May 21, 2018
IDEA PUBLIC SCHOOLS – IDEA Brownsville Robindale Phase I

ADDENDUM NO. 1

A. PURPOSE AND INTENT
This addendum is issued for the purpose of modifying the plans and specifications for the IDEA PUBLIC SCHOOLS – IDEA Brownsville Robindale Phase I

Date:	May 10, 2018
Scale:	As Noted
Project Architect:	David Monreal, AIA
Drawn By:	ETHOS
Job No.	IDEA Robindale Phase I
Sheet:	E4.04

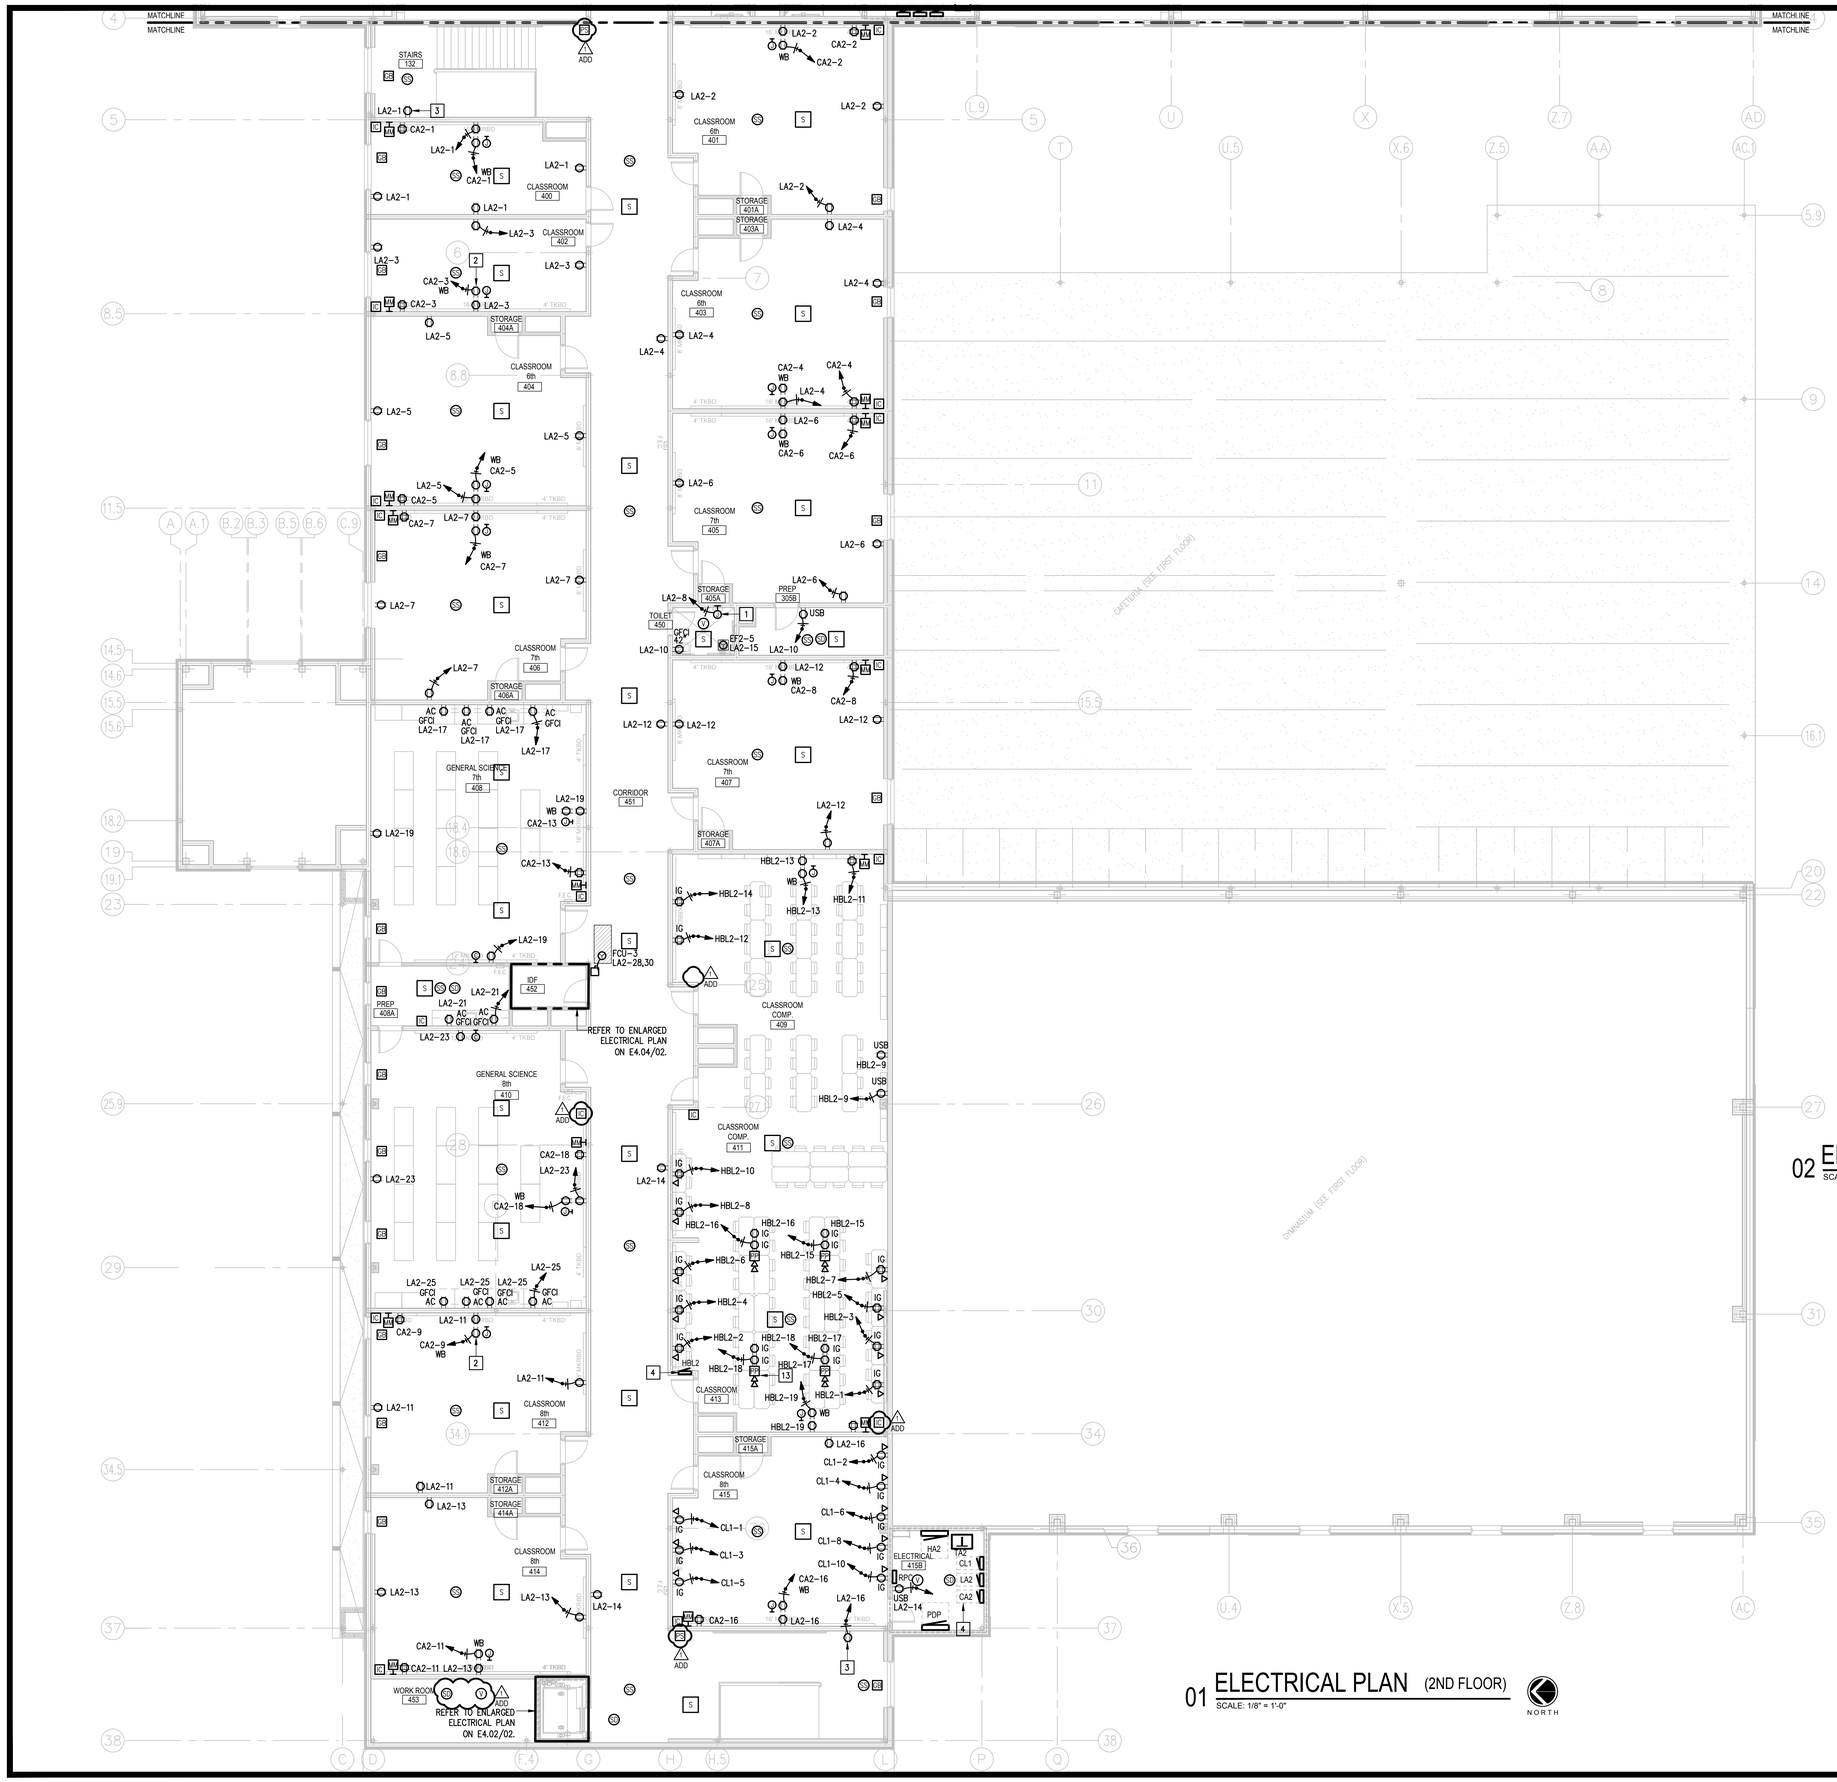
12) Sheet E4.04:
   d) Revised Second Floor Electrical Plan. See attached sheet.

Date: May 10, 2018
Scale: As Noted
Project Architect: David Monreal, AIA
Drawn By: ETHOS
Job No. IDEA Robindale Phase I
Sheet: E4.05

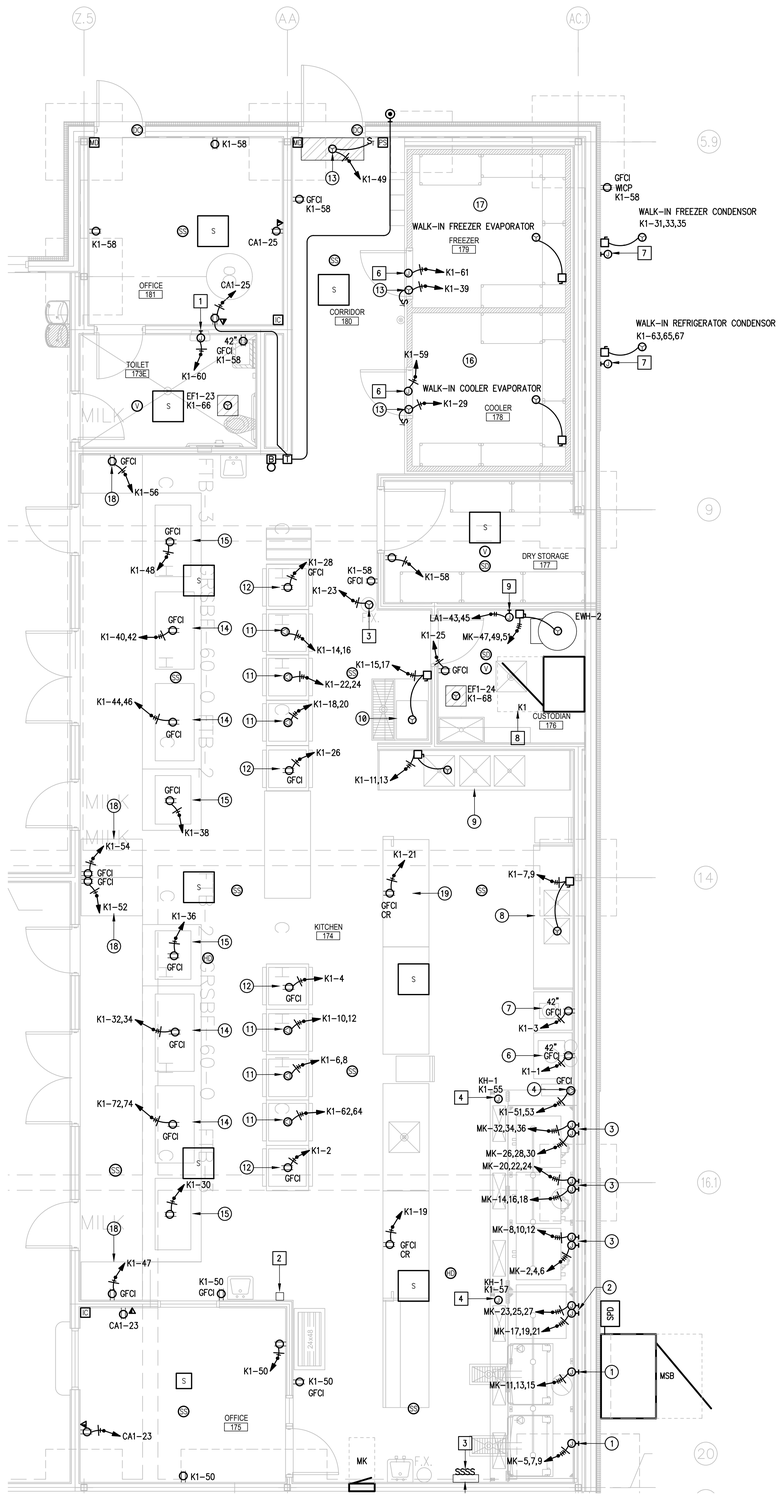
13) Sheet E4.05:
   a) Revised Electrical Plan. See attached sheet.

Date:	May 10, 2018
Scale:	As Noted
Project Architect:	David Monreal, AIA
Drawn By:	ETHOS
Job No.	IDEA Robindale Phase I
Sheet:	P2.01

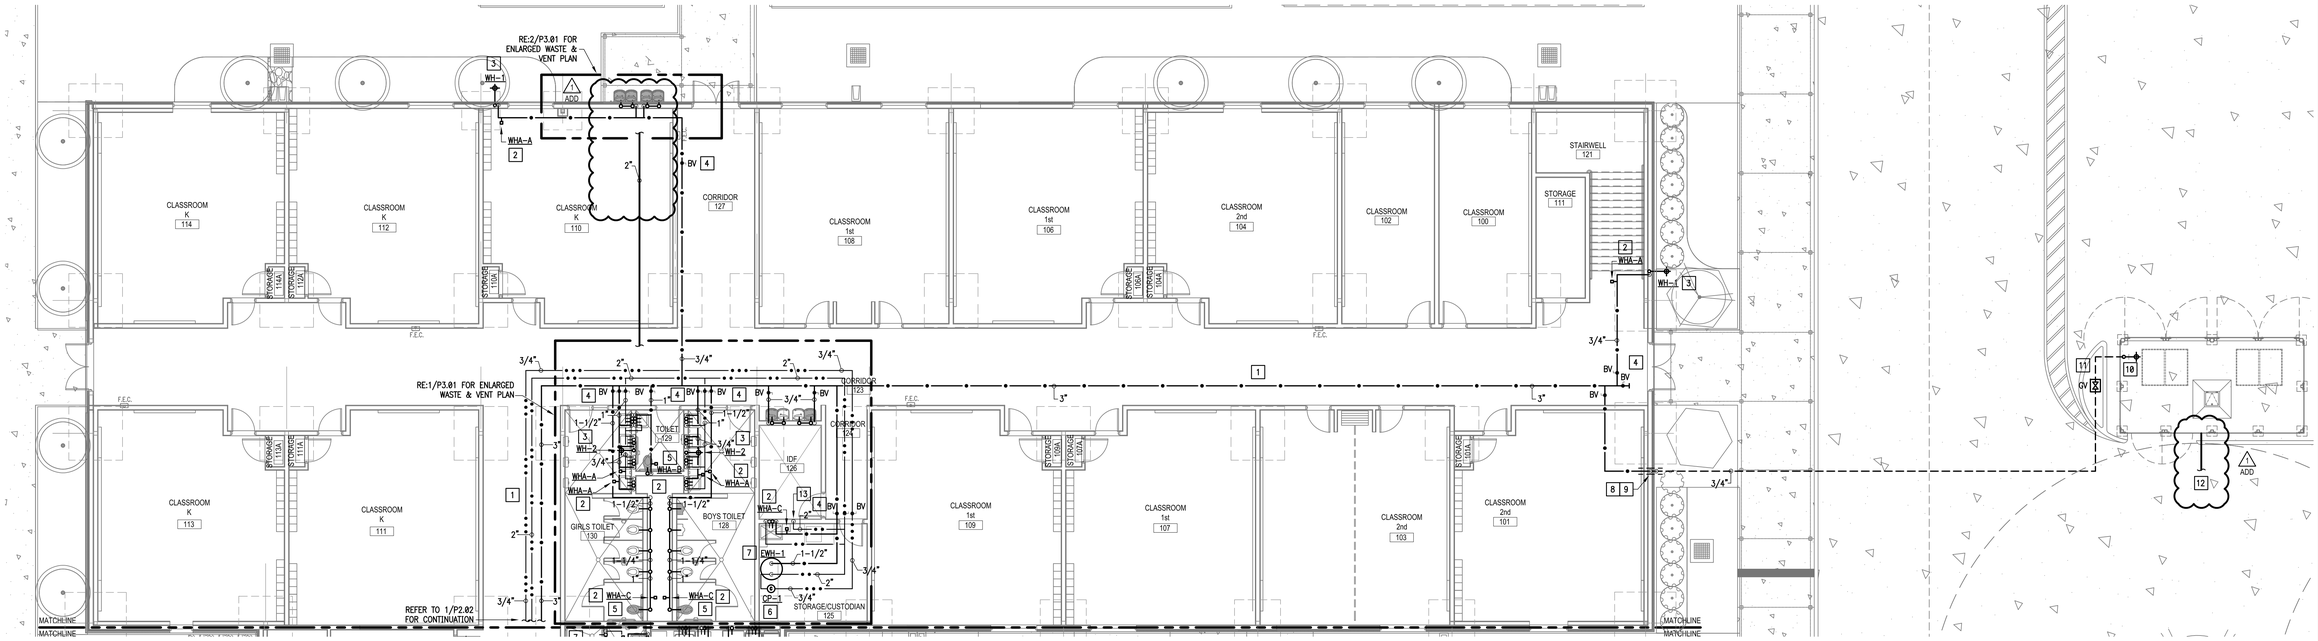
15) Sheet P2.01
   a) Revised water connection for exterior drinking fountains. See attached sheet.

Date:	May 10, 2018
Scale:	As Noted
Project Architect:	David Monreal, AIA
Drawn By:	ETHOS
Job No.	IDEA Robindale Phase I
Sheet:	P2.02

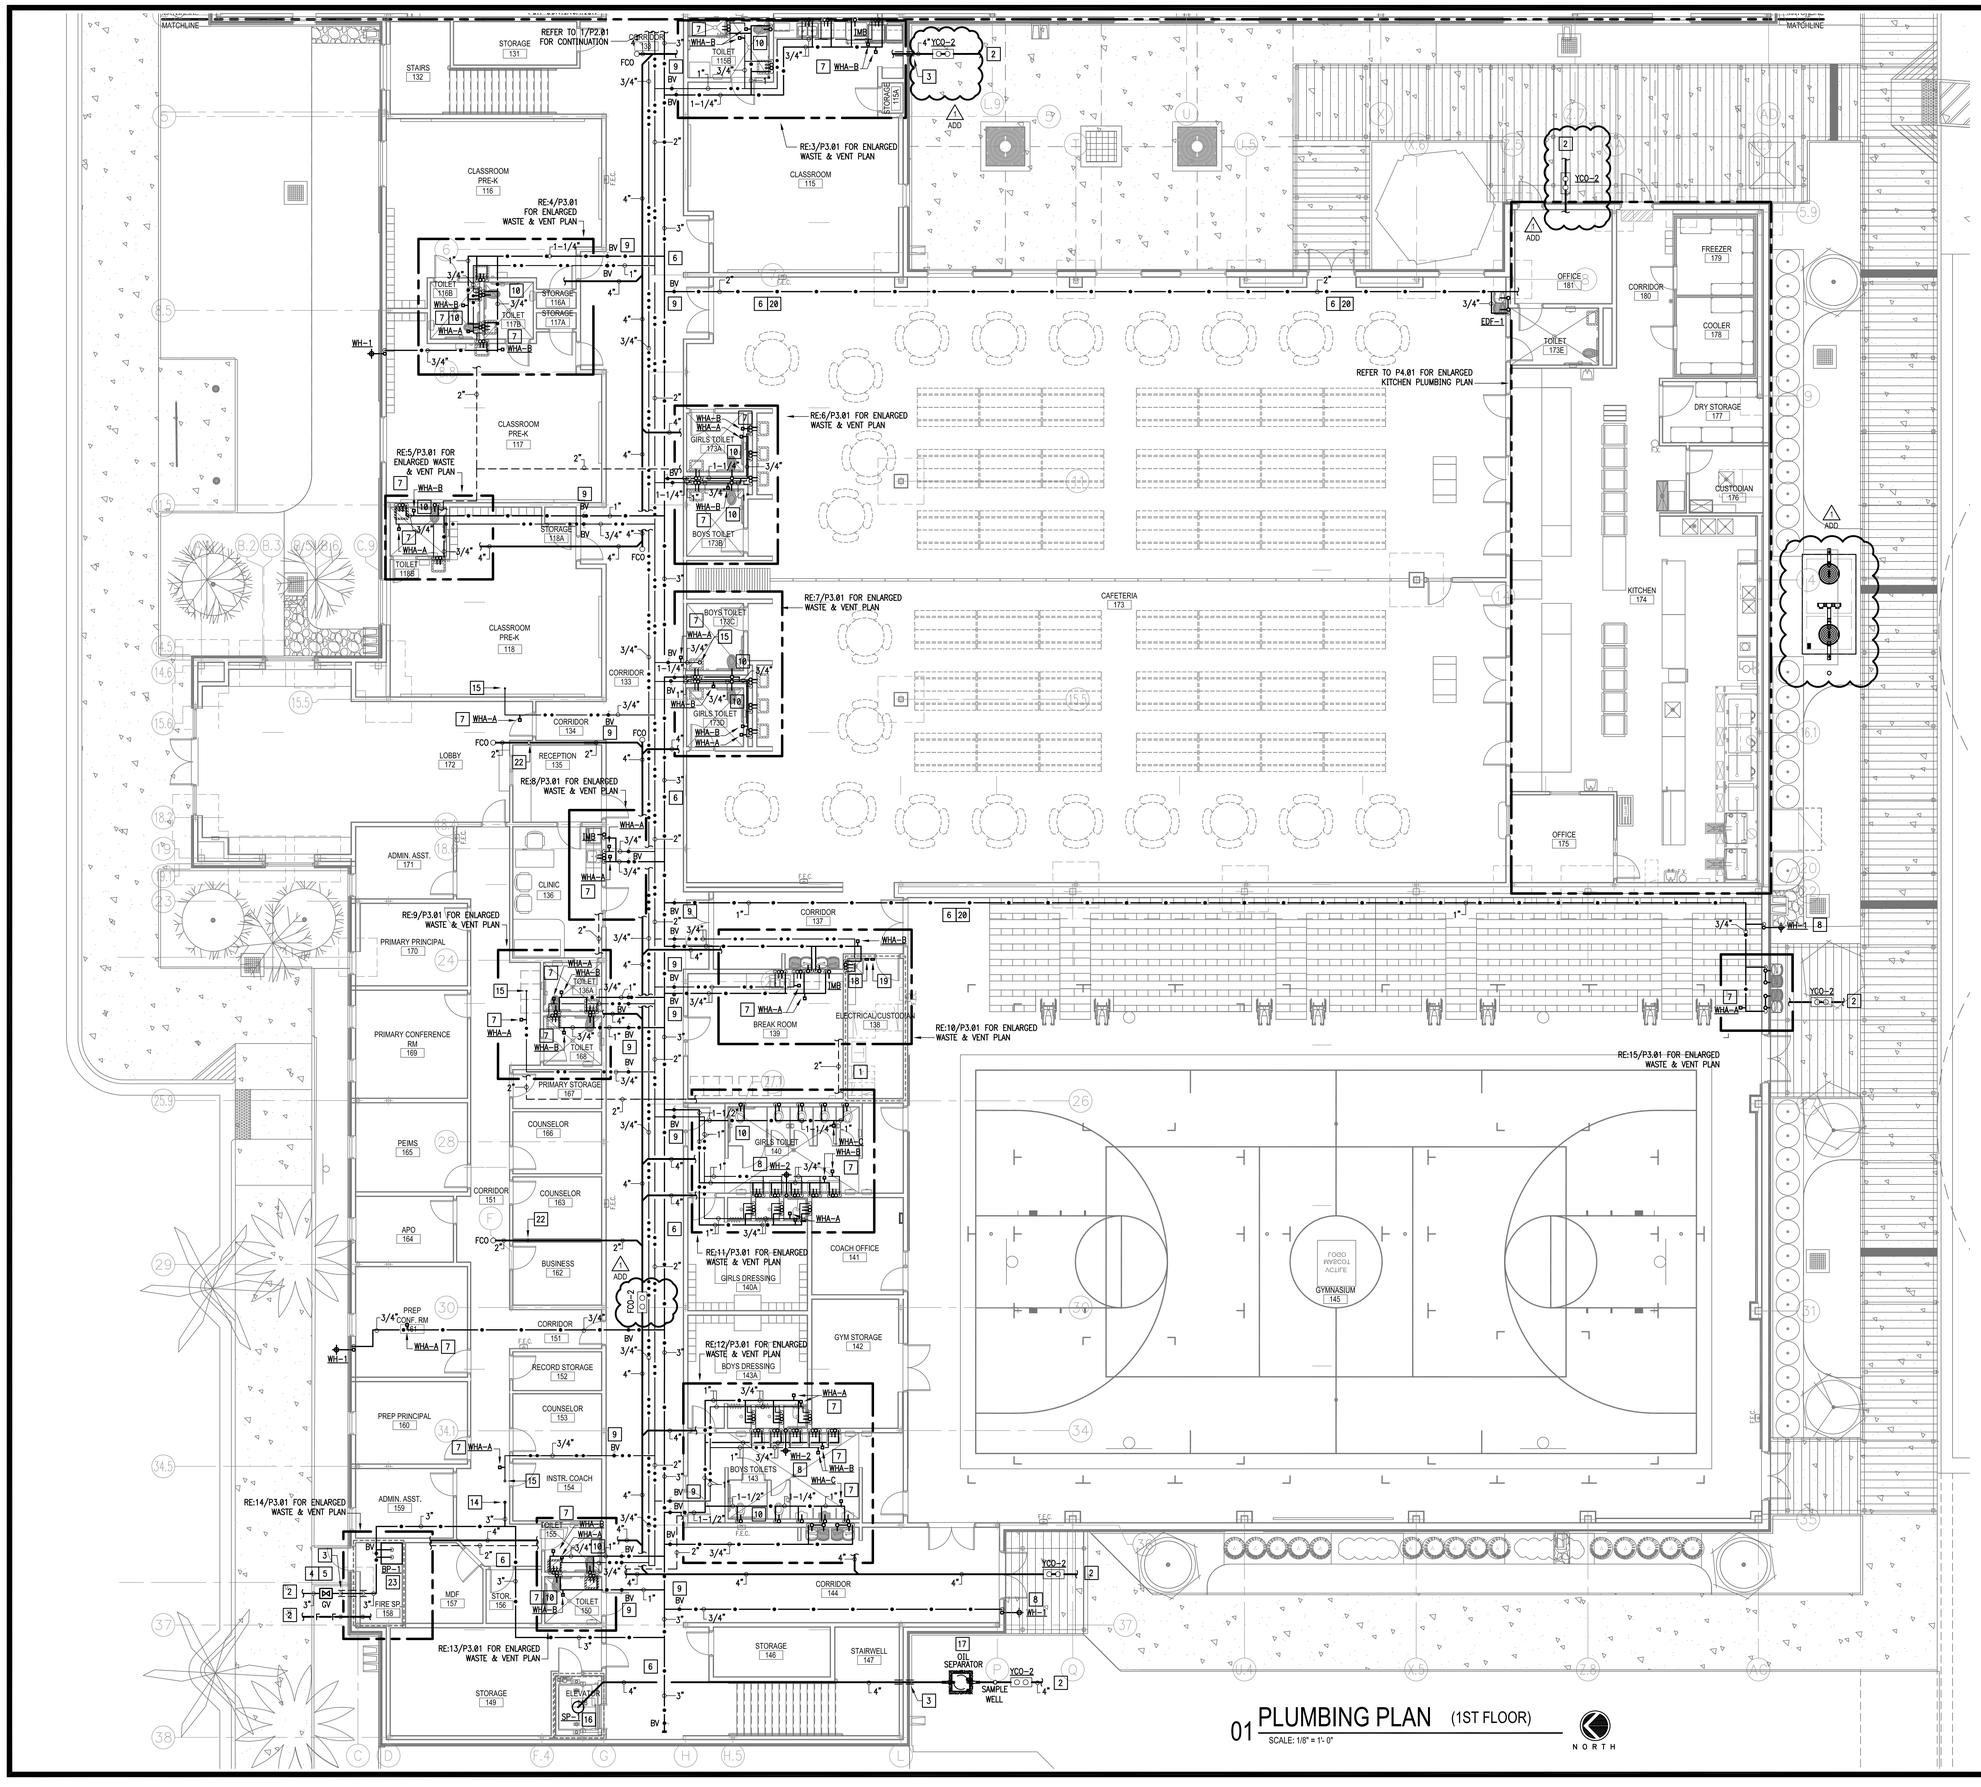
16) Sheet P2.02:
   a) Revised grease trap location. See attached sheet.
   b) Revised stub outs at Classroom 115 and Kitchen. See attached sheet.
   c) Revised cleanout at Corridor 133. See attached sheet.

Date: May 10, 2018
Scale: As Noted
Project Architect: David Monreal, AIA
Drawn By: ETHOS
Job No. IDEA Robindale Phase I
Sheet: P2.03

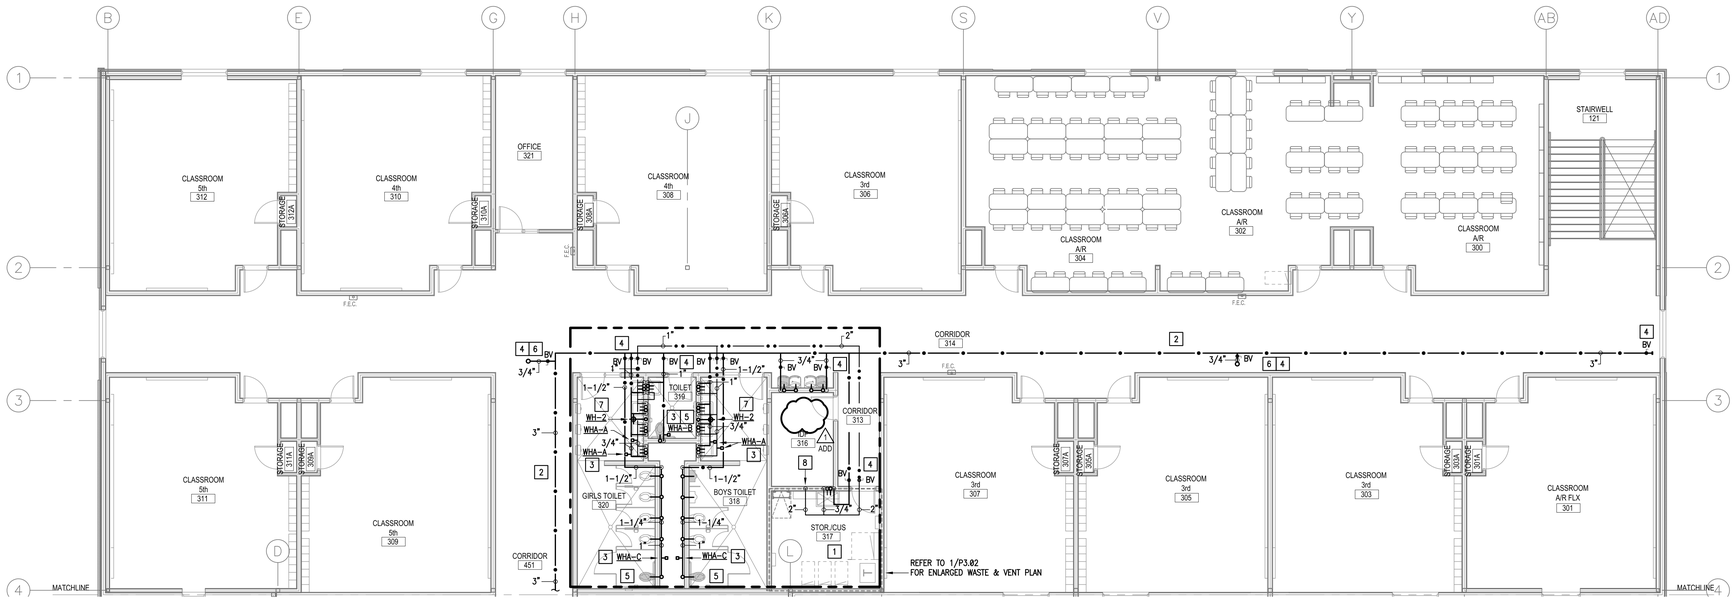
17) Sheet P2.03:
   a) Revised plumbing keynote at IDF 316. See attached sheet.

Date: May 10, 2018
Scale: As Noted
Project Architect: David Monreal, AIA
Drawn By: ETHOS
Job No. IDEA Robindale Phase I
Sheet: P3.01

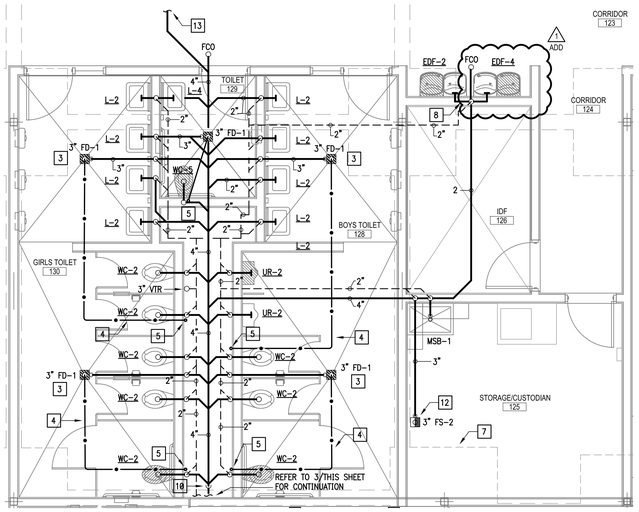
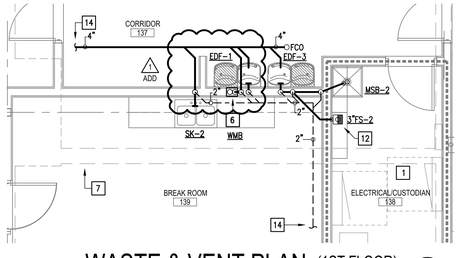
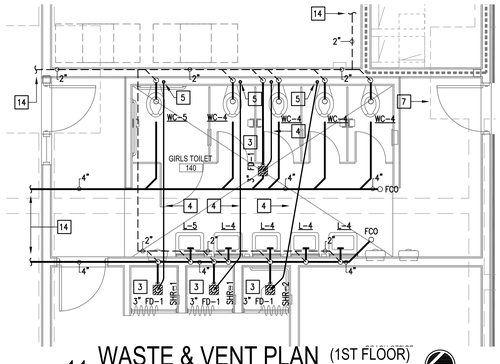
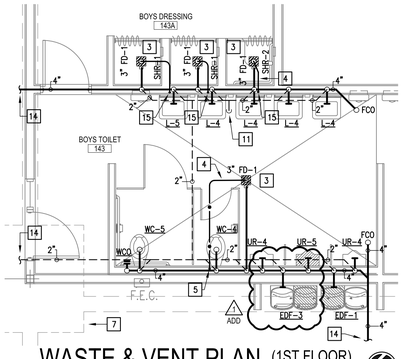
18) Sheet P3.01:
   a) Revised drinking fountain designation at multiple locations. See attached sheet.
   b) Revised sanitary routing at Toilet 136A. See attached sheet.
